PEACEFUL RIDGE AT FOUNTAIN VALLEY SUBDIVISION

RESIDENTIAL SUBDIVISION CONSTRUCTION DRAWINGS

EPC STORMWATER REVIEW COMMENTS ARE SHOWN IN ORANGE BOXES WITH BLACK TEXT

TYPICAL STREET SECTION

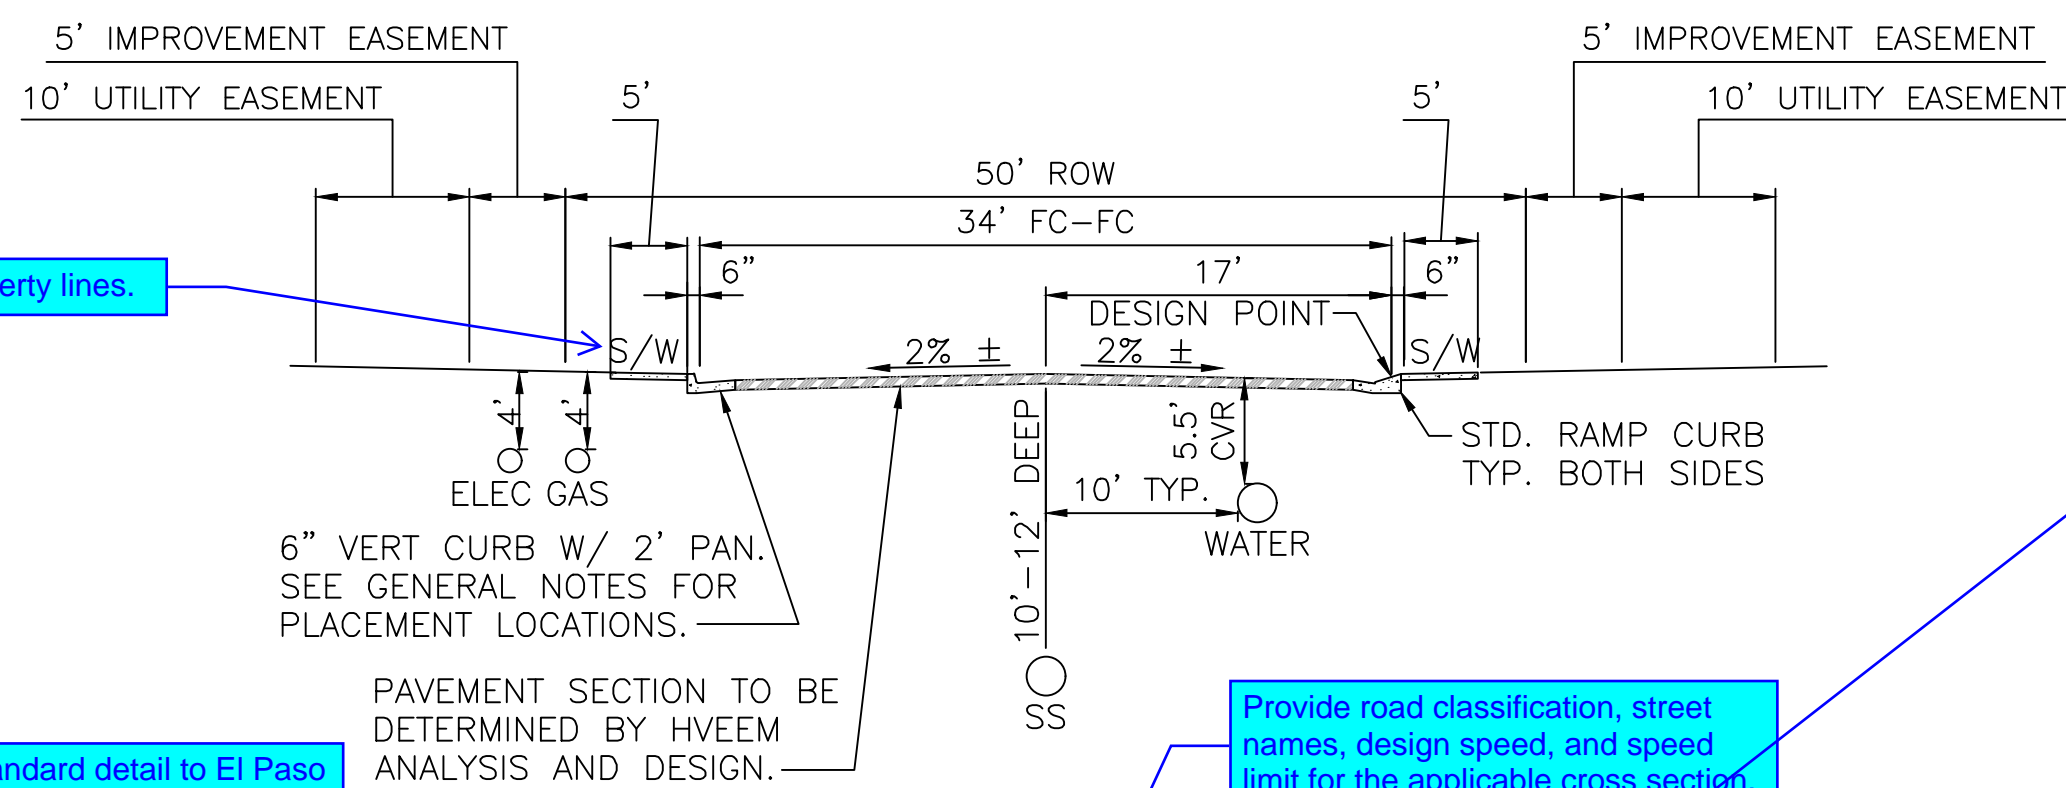
Revise standard detail to El Paso County SD 2-40 Pedestrian Curb Ramp Detail and add detail to drawing set.

Provide road classification, street names, design speed, and speed limit for the applicable cross section.

TYPE III VERTICAL CURB AND GUTTER

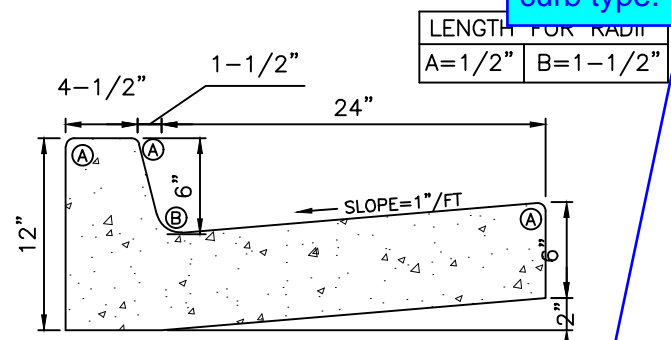
Revise to use County nomenclature for curb type.

PEACEFUL RIDGE AT FOUNTAIN VALLEY SLEEPY MEADOWS DRIVE PLAN AND PROFILE

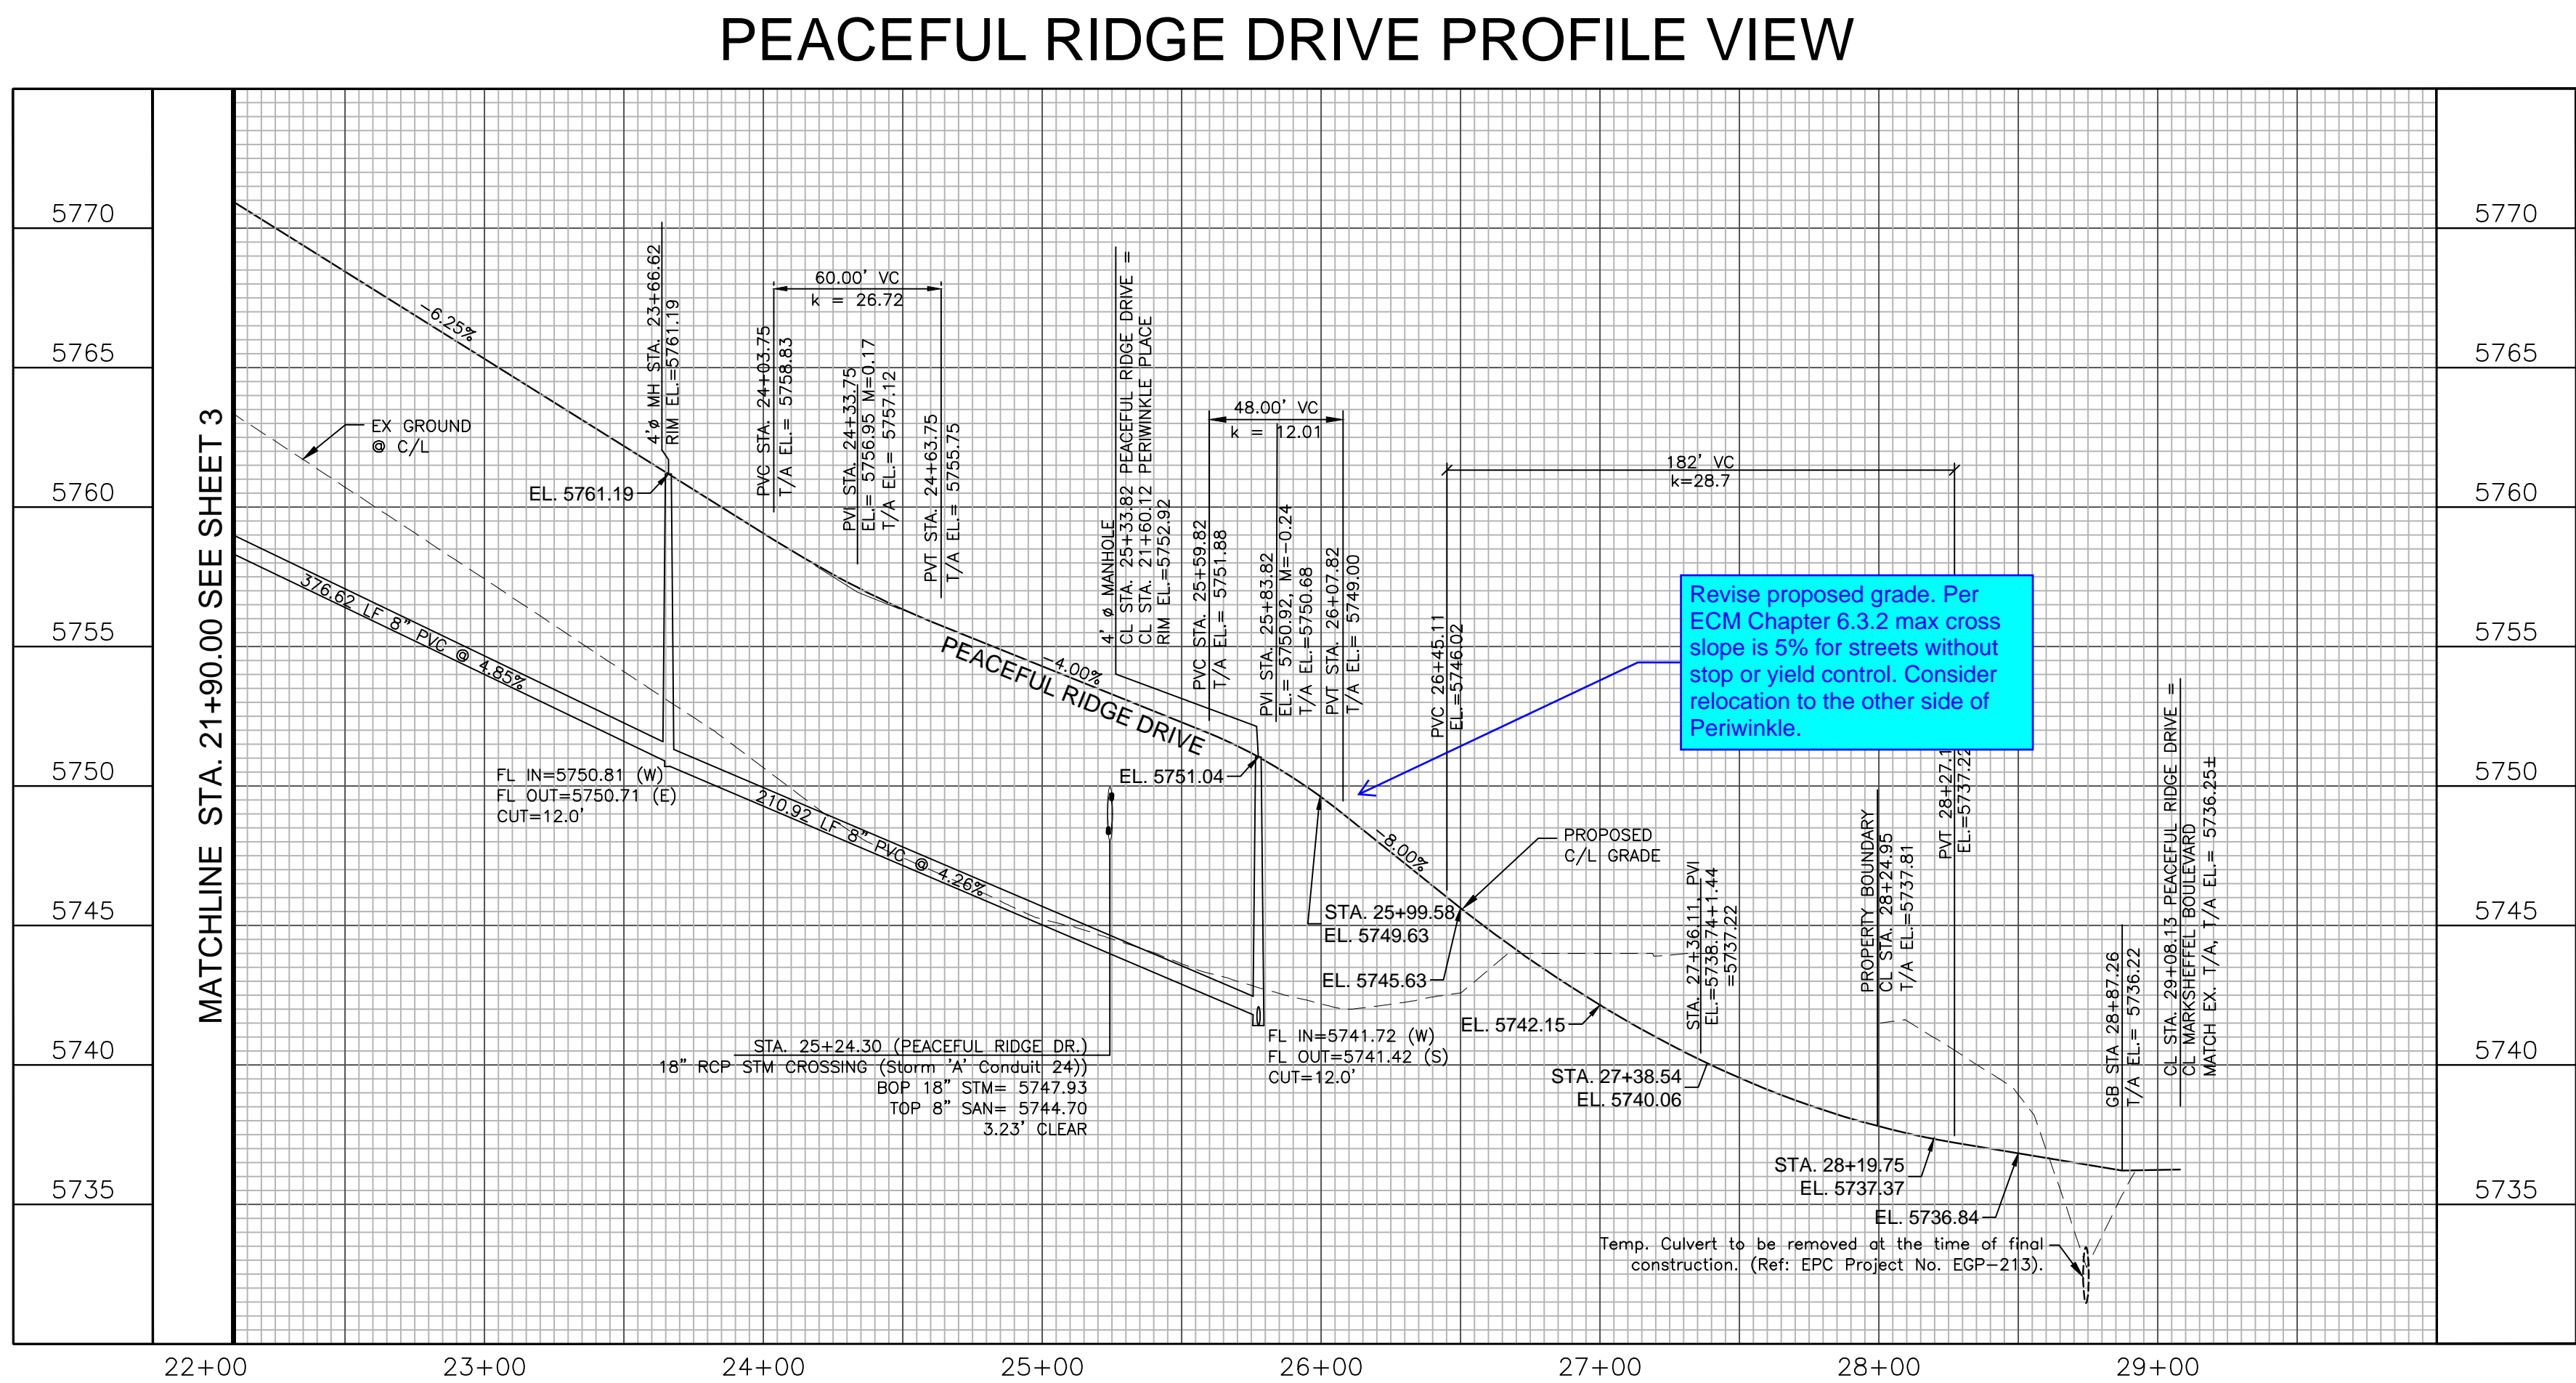
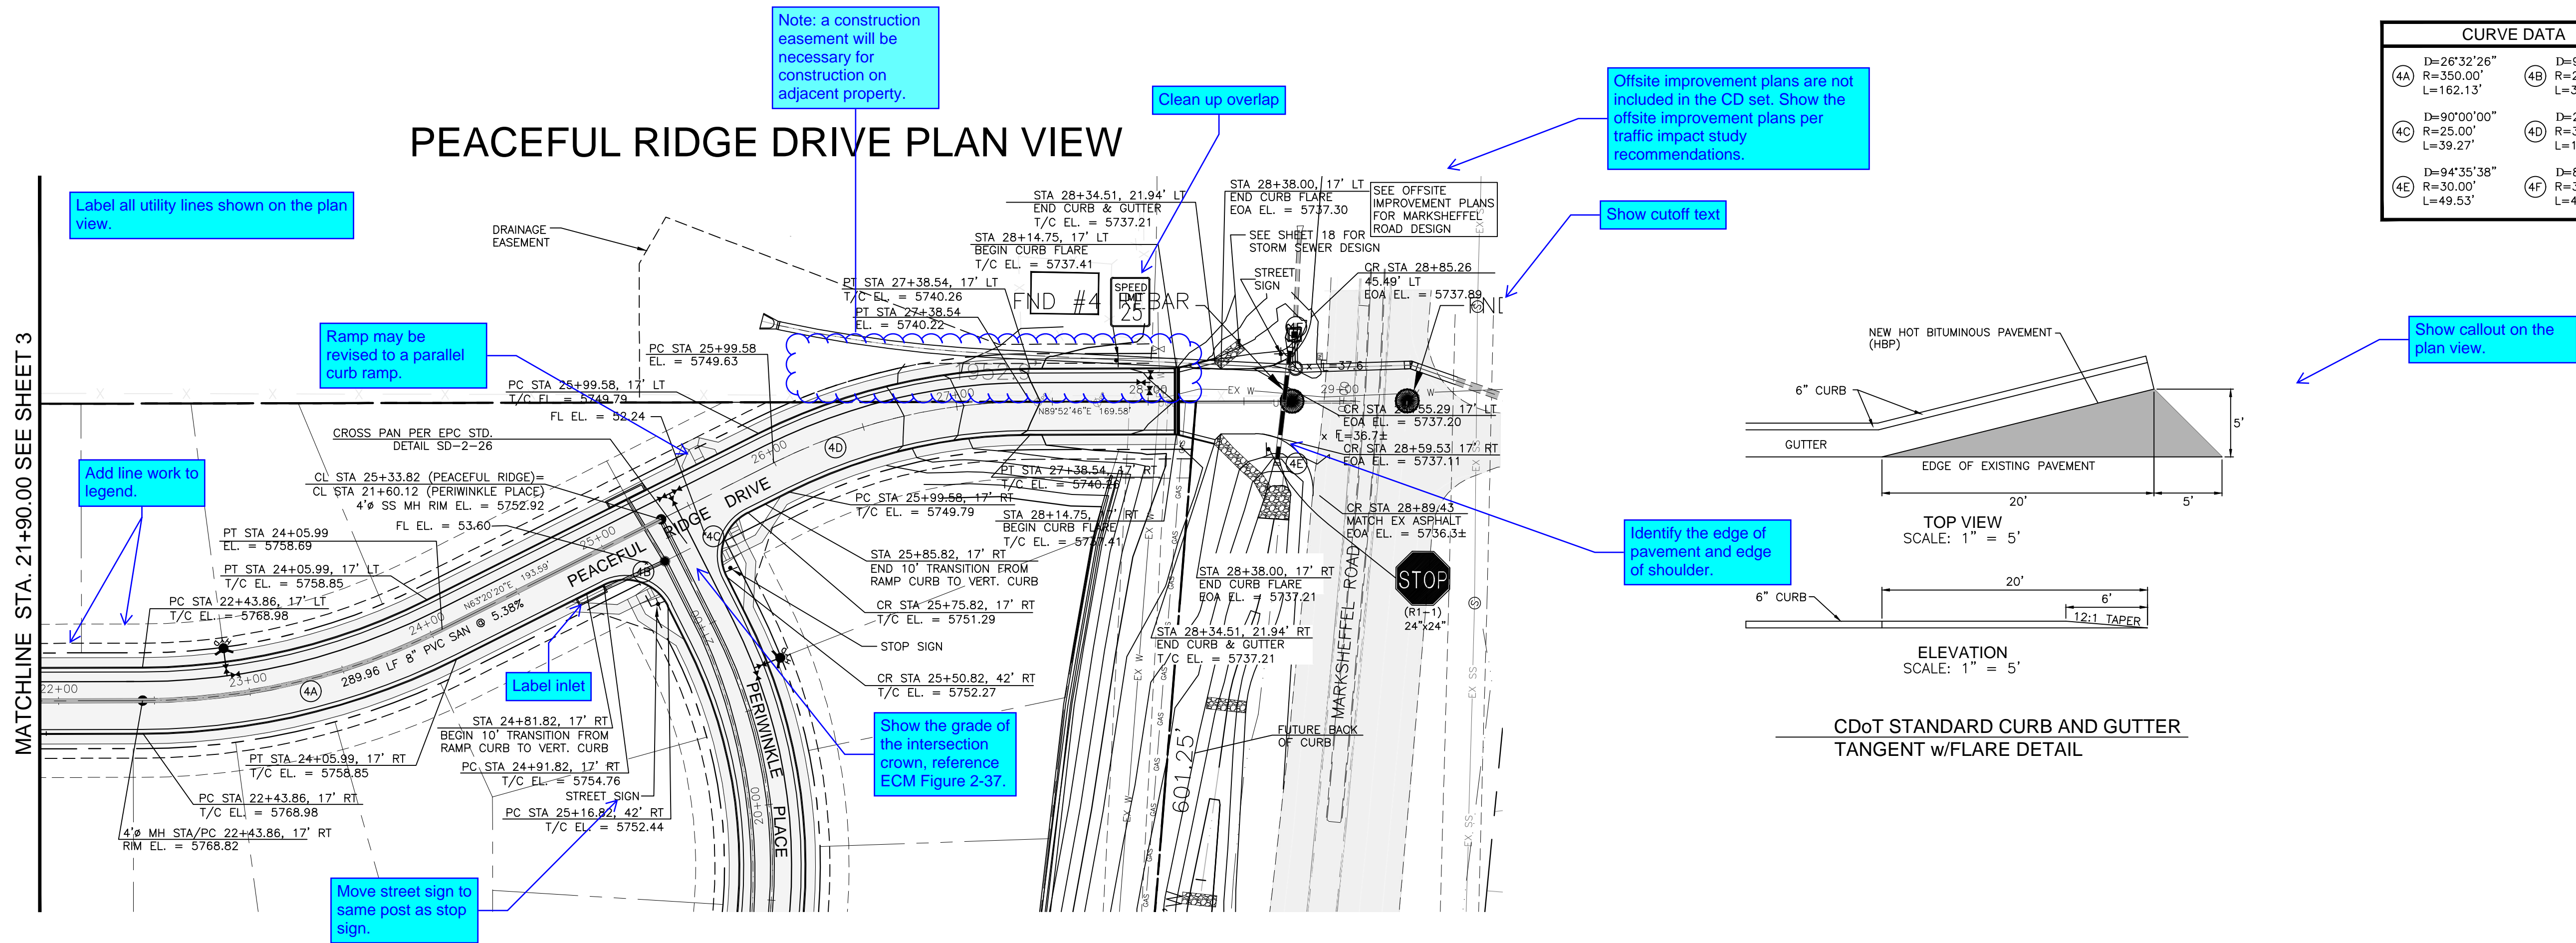
Identify all utility lines as existing or proposed.

Add and label plan matchlines

Label inlets

Label proposed lot numbers

Verify sidewalks are not in private property.

Recommend revising to a parallel curb ramp, and following ECM Chapter 6.3.3 criteria for all typical designs in the construction drawing set. If design is revised add Parallel Pedestrian Curb Ramp Detail Standard Drawing SD-2.50 to construction drawings and add callout.

Knuckle designs do not meet EPC SD-2.77, please submit deviation requests for knuckles for documentation.

Label utility line

Label as existing or proposed.

Remove highlighted pedestrian cross ramps.

Per El Paso County Standard Signing and Striping notes street name and regulatory stop signs shall be on the same post at intersections. Please move street sign to the same post as stop sign.

Label all manholes consistent with the drainage report naming (i.e. MH-1A, etc).

For all pedestrian street crossings, pedestrian curb ramps, and sidewalks show running slopes, cross slope, and elevation spot checks. See attached screenshot for reference. Review ECM Chapter 6 for design criteria.

Show match lines in the profile views.

provide vertical scale at all profile sheets
